GENESEE COUNTY PLANNING BOARD REFERRALS NOTICE OF FINAL ACTION

T-04-BER-07-24

Site Plan Review and Area Variance for an Approx. 10,640 sq. ft. new commercial retail building (Dollar General) and associated site improvements on vacant land within Apple Tree Acres Business Park.

**RE: NEW 10,640 SF +/- COMMERCIAL RETAIL SPACE
INTERSECTION OF BUFFALO ROAD AND APPLE TREE AVENUE
PRELIMINARY SITE PLAN AND STORMWATER POLLUTION PREVENTION PLAN (SWPPP) REVIEW
MRB GROUP PROJECT NO. 0202.24000.000 – PHASE 007**

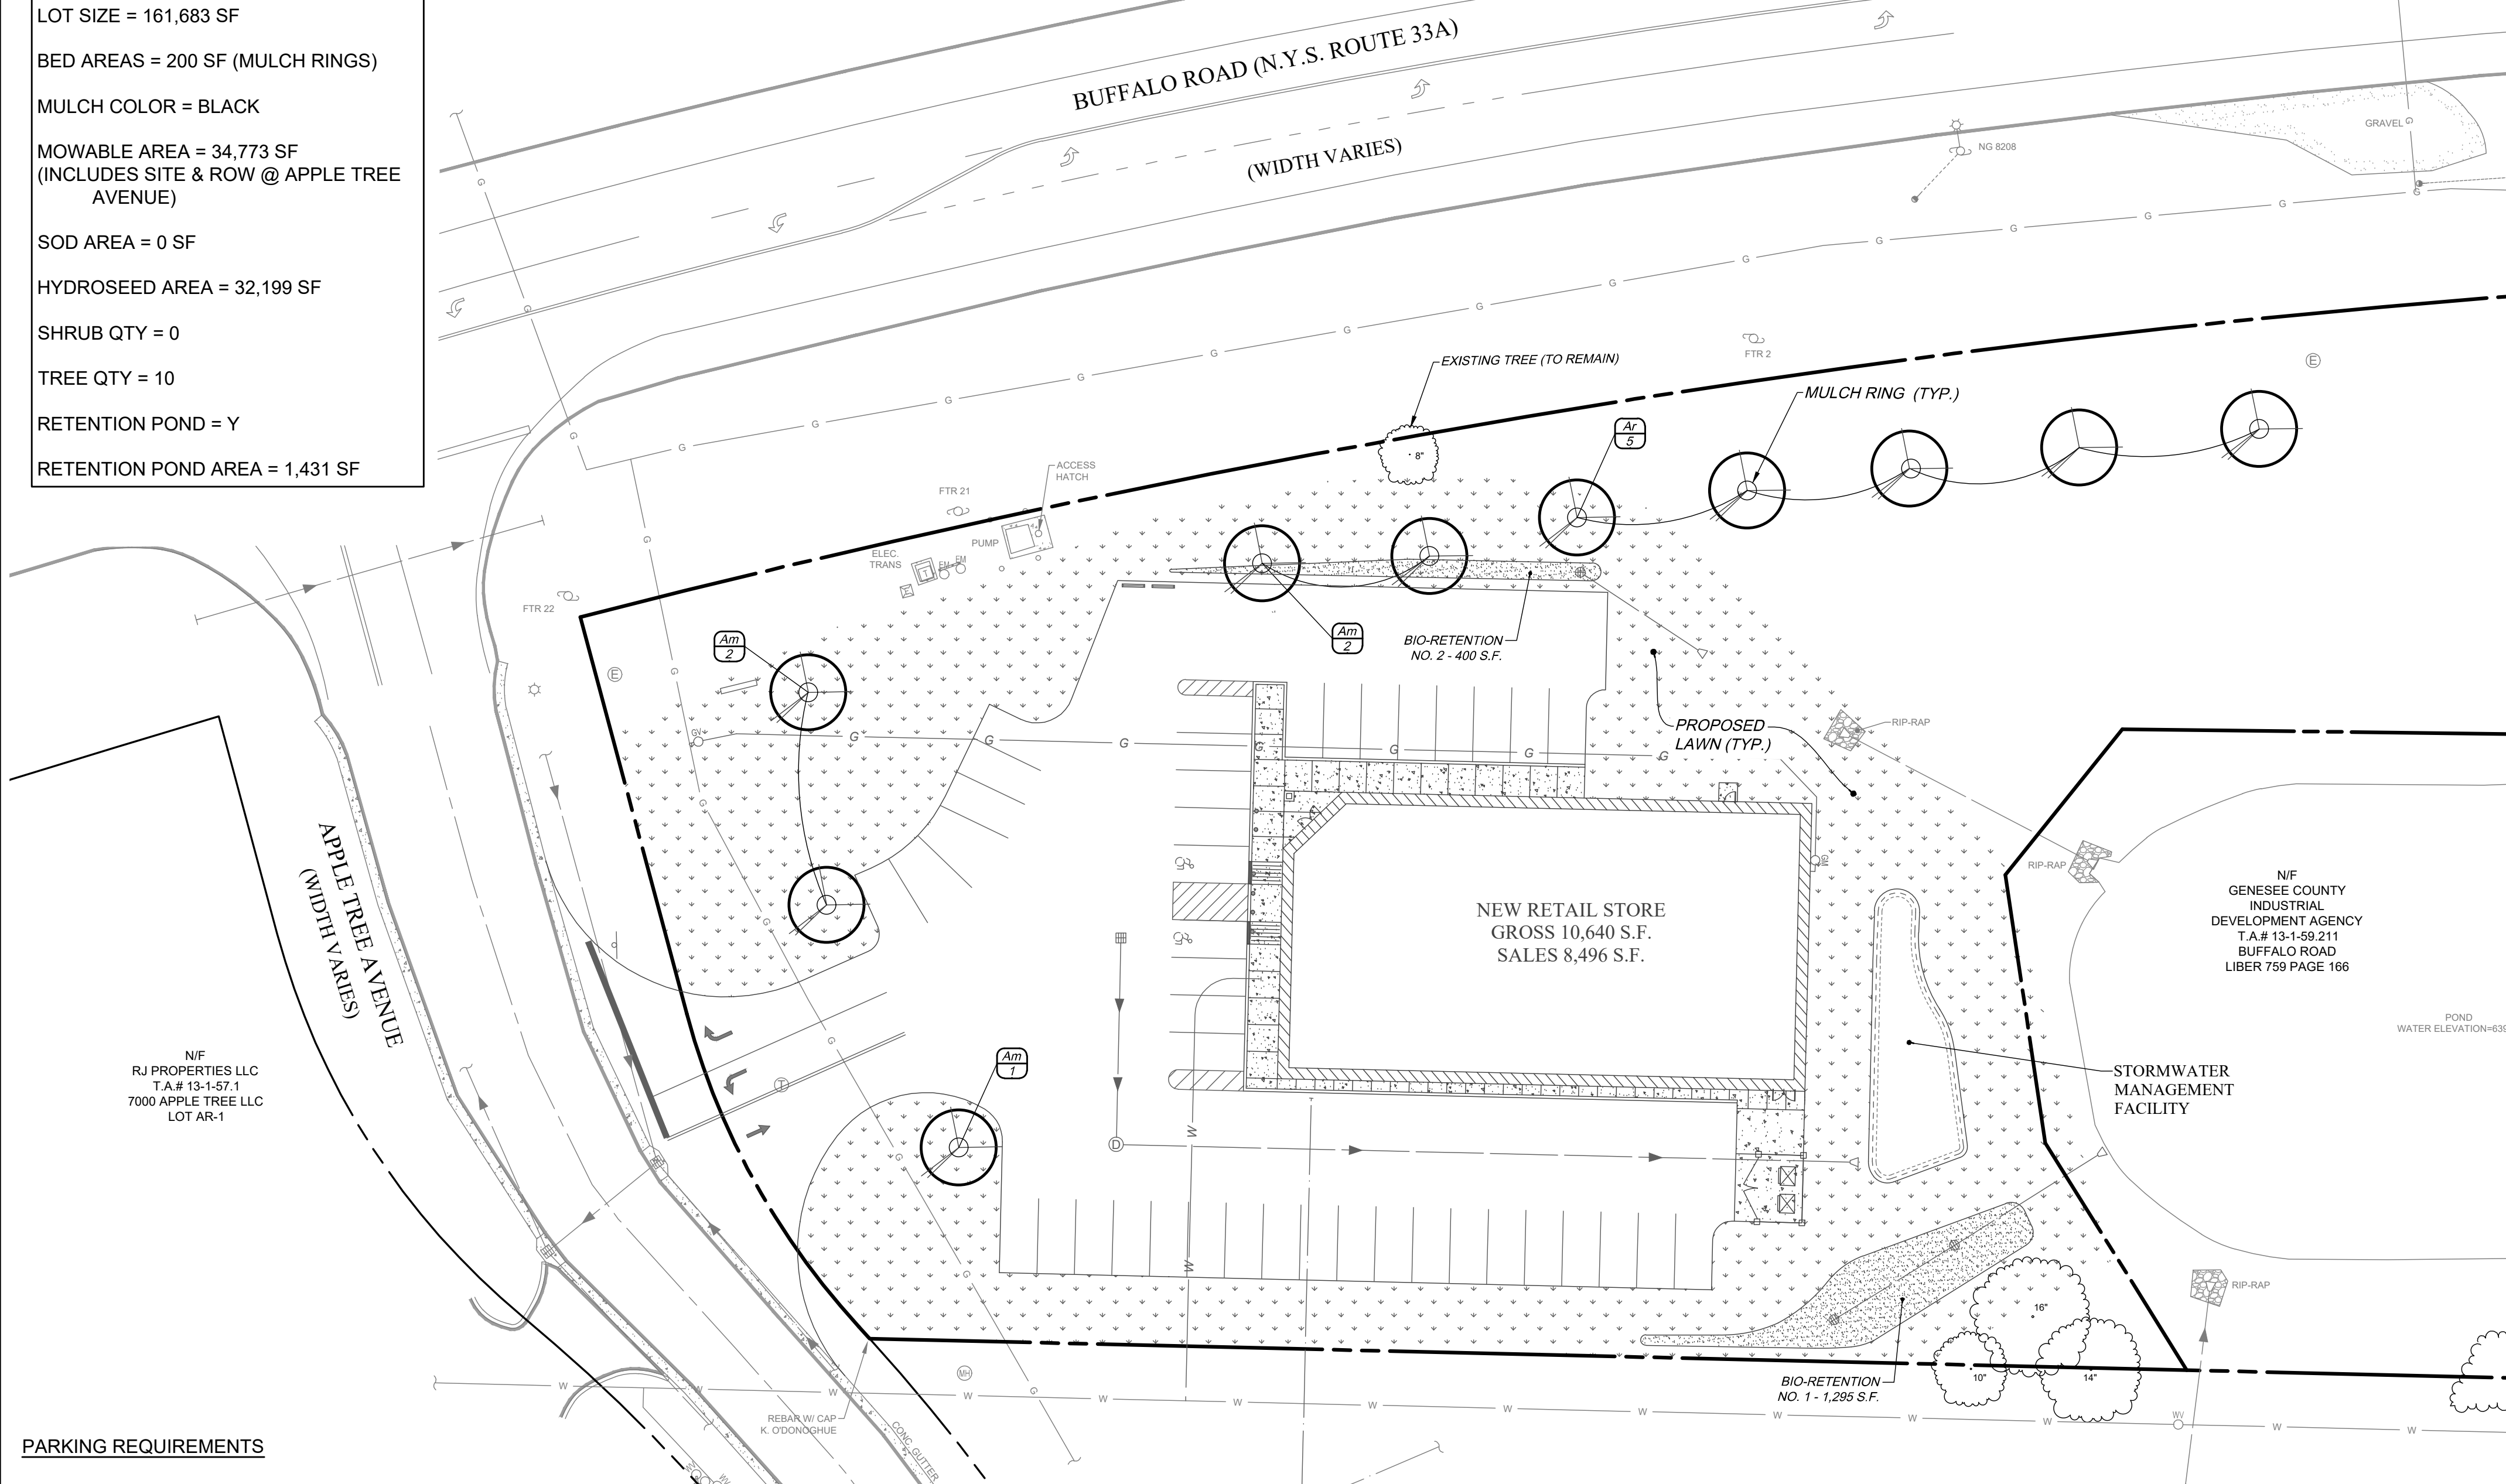
9. The following comments pertain to the Landscaping Plan (Sheet LA-100):
 - a. Under "site estimates", the postconstruction conditions lists that the impervious area will cover 30.5% of the site (revised from the original submittal value of 31.7%); however, in the Application Package as well as on sheet CA-110, the lot coverage is proposed to be 29.7%. Per Town Code Schedule A, the maximum lot coverage is to be 30%. Please verify what the proposed coverage is.

8. The following comments pertain to the Landscaping Plan (Sheet LA-100):
 - a. Under "site estimates", the postconstruction conditions lists that the impervious area will cover 31.7% of the site; however, in the Application Package as well as on sheet CA-110, the lot coverage is proposed to be 29.7%. Per Town Code Schedule A, the maximum lot coverage is to be 30%. Please verify what the proposed coverage is.
 - b. Please provide a schedule/detail that summarizes the proposed seeding and planting requirements for the bio-retention area.
